## **LABRADOR RUN SUBDIVISION,** **PHASE THREE B**

APPLICATION NUMBER 1 DATE September 7, 2017

APPLICANT Labrador Run Phase Three B Subdivision

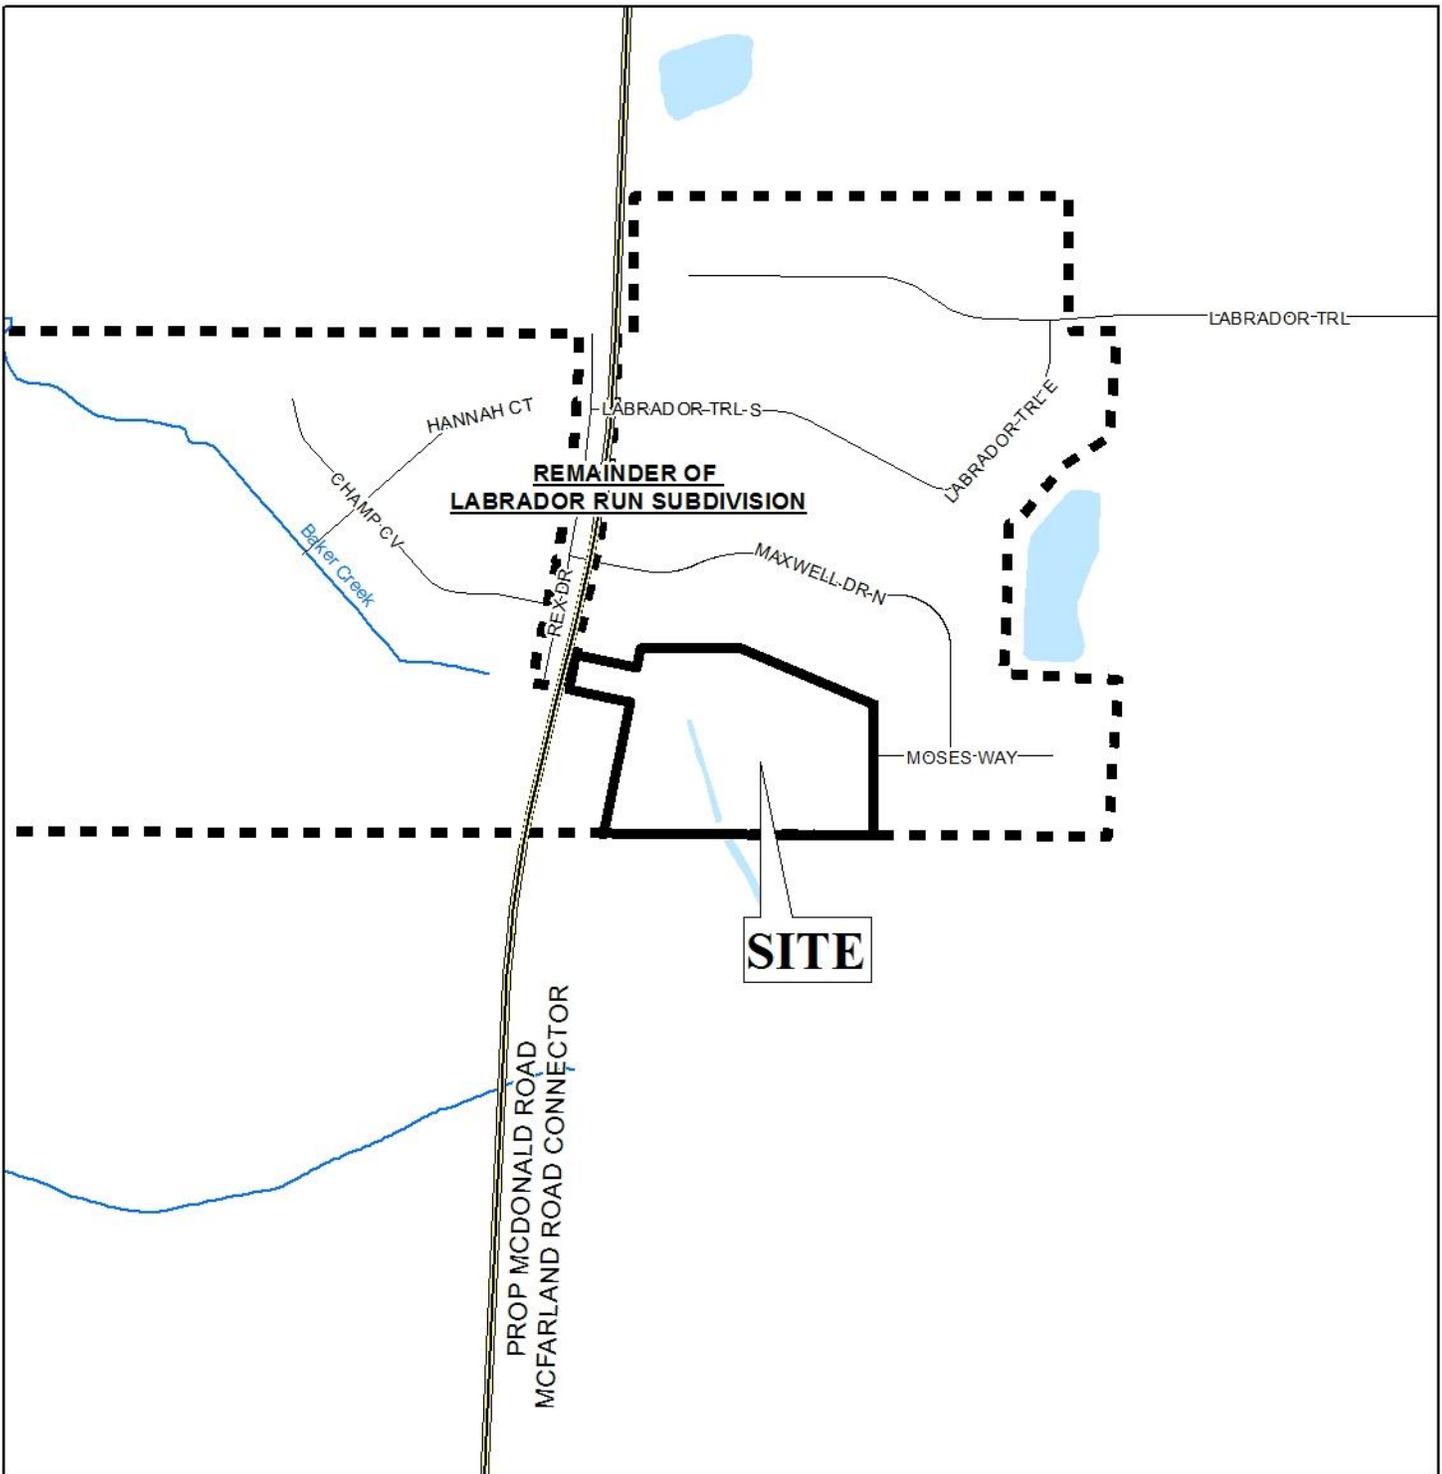
*Staff received a revised Master Plan of Labrador Run Subdivision whereon Phase Three B, as provided for the August 3<sup>rd</sup> meeting, is illustrated. No reconfiguration of Lot 14 is proposed, and no changes to previously proposed and/or approved phases of the master subdivision are indicated.*

*It should be noted that, while the Master Plan is depicted as being consistent with previously approved and currently proposed phases, neither Phase Three B nor Phase Three A are labeled. As such, revision of the Master Plan to correctly identify Phases Three A and B should be required prior to signing of the Final Plat.*

- 2) revision of the Master Plan of Labrador Run Subdivision to correctly label Phases Three A & B;*
- 3) placement of a note on the Final Plat stating Lots 1-13 are each limited to one curb cut to Moses Road, and Lot 14 is limited to one curb cut to Rex Drive, with any changes in their sizes, locations, or designs to be approved by Mobile County Engineering and conform to AASHTO standards;*

# DETAIL SITE PLAN

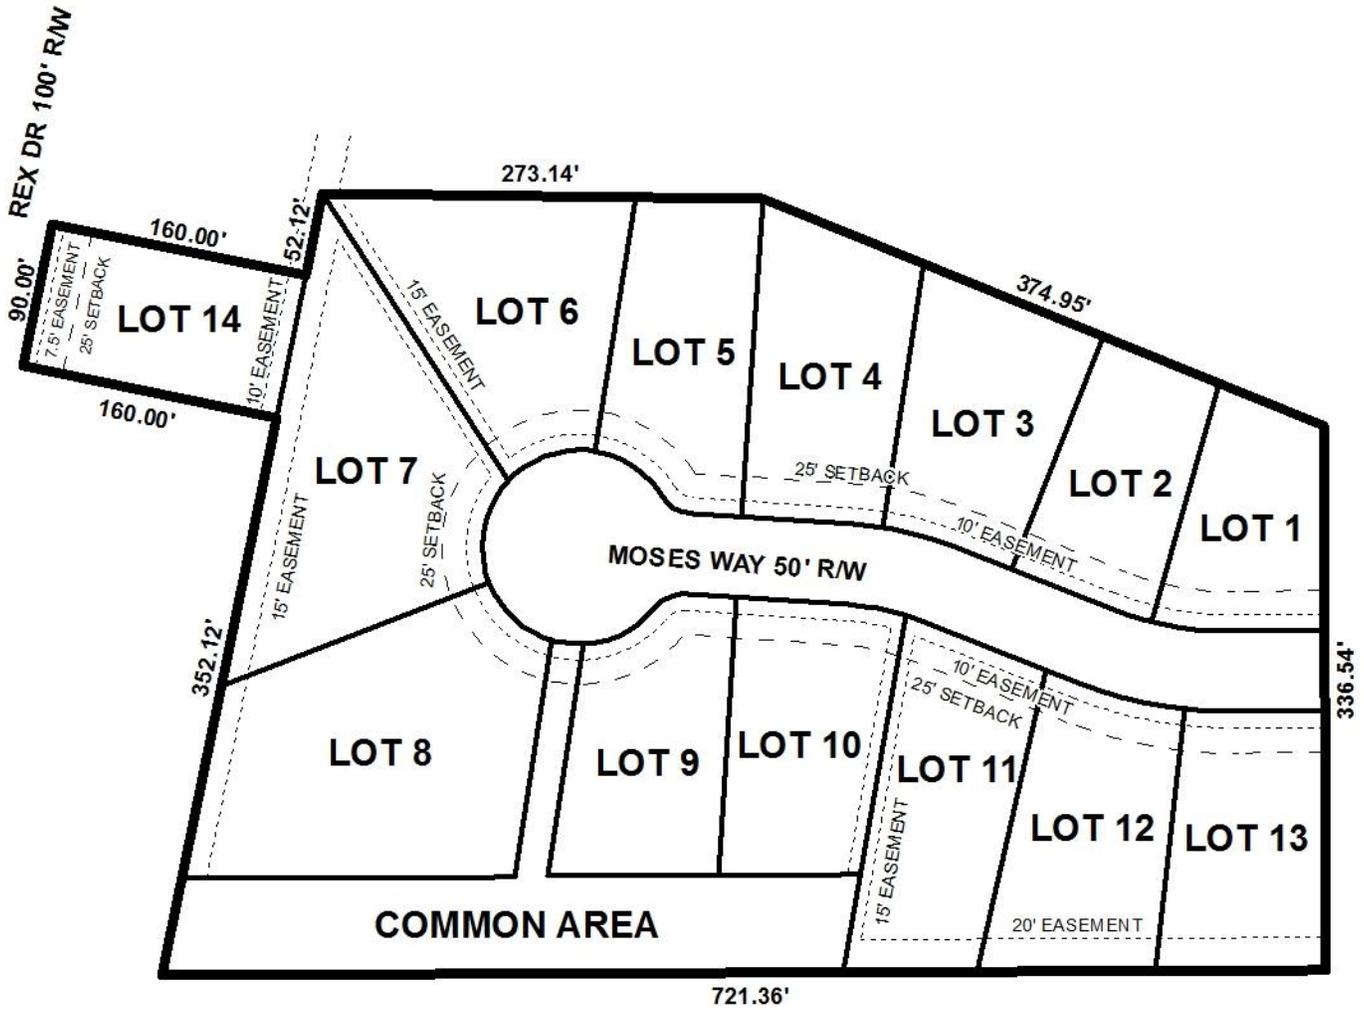
The preliminary plat illustrates the proposed construction of an extension to Moses Way, a minor closed-end street with curb and gutter requiring a 50' right-of-way width. Lots 1-13 front the proposed street, whereon sufficient right-of-way is depicted; and, as such, no additional dedication should be required.

Regarding proposed Lot 14, the applicant may wish to consider reconfiguring the lot as a second point of access to the proposed subdivision phase. Doing so would facilitate connectivity between existing and future subdivision phases. It should nevertheless be noted that Lot 14 has frontage on Rex Drive, a future major street named Airport Road Extension requiring a 120' right-of-way width per the most recently adopted Major Street Plan. The preliminary plat illustrates a 100' right-of-way; therefore, if approved, the plat should be revised to illustrate dedication sufficient to provide a minimum of 60' from the centerline of Rex Drive.

It should also be noted that Rex Drive terminates as a street stub in an area labeled "Future Development." As such, if approved, and if required by Mobile County Engineering, a temporary turn-around in compliance with Sections V.B.6. and V.B.14. of the Subdivision Regulations should be illustrated on the Final Plat at the terminus of Rex Drive. Any proposed street(s) must be built to Mobile County Engineering standards and be accepted by Mobile County prior to the signing of the Final Plat.

As a means of access management, a note should be required on the Final Plat stating Lots 1-13 are each limited to one curb cut to Moses Road, and Lot 14 is limited to one curb cut to Rex Drive, with any changes in their sizes, locations, or designs to be approved by Mobile County Engineering and conform to AASHTO standards.

The preliminary plat illustrates the 25' minimum building setback line along both existing and proposed street frontages, per Section V.D.9. of the Subdivision Regulations. If approved, this information should be retained on the Final Plat, adjusted for any required dedication.

The lots, with the exception of Lot 14, are slightly irregular in shape, but meet the minimum size requirements for lots served by a public water supply and sanitary sewer system. Also, each lot's size is appropriately labeled in square feet and acres. If approved, this information should be retained on the Final Plat, adjusted for any required dedication; or, provision of a table with the same information should suffice.

Multiple easements are illustrated on the preliminary plat, including the following: a 10' utility easement along the frontages of Lots 1-13; drainage easements 20' wide along the rear portions of Lots 11-13, and 10' wide along the rear portion of Lot 14; and, drainage and utility easements 7.5' wide along the frontage of Lot 14, 15' wide between Lots 6 and 7, 15' wide between Lots 10 and 11, 15' wide along the rear portions of Lots 7 and 8, and 20' wide along the rear of Lots 11-13. A note stating no permanent structures can be constructed in any easement has been placed on the preliminary plat and should be retained on the Final Plat, if approved.

The plat depicts a 0.65± acre common area to the rear of Lots 8-10, with a 20'±-wide access between Lots 8 and 9 from Moses Way. A note referencing the maintenance of the common area has been placed on the preliminary plat and should be retained on the Final Plat, if approved.
